# Updated Compressor Design: 6512480

TECH TIP

#204

gpd now offers an updated compressor design for 6512480 for:

### UPDATED DESIGN

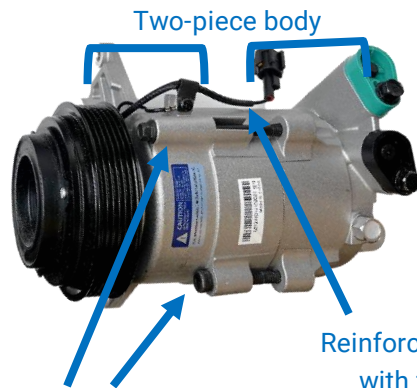
- Reinforced electrical connector with flexible wiring cover
- Two-piece body design vs. previous three-piece body design
- Four exterior body bolts vs. previous body design with five interior bolts
- Rear redesigned to protect rear studs/bolts

### UPDATED DESIGN

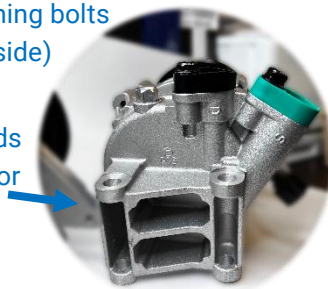
Redesigned as a two-piece body with four external fastening bolts.

Four external fastening bolts  
(Two on each side)

No visible studs/bolts  
on rear of compressor

External appearance matches OE design.

Fastening bolts not visible on exterior

Studs/bolts visible  
on rear of compressor
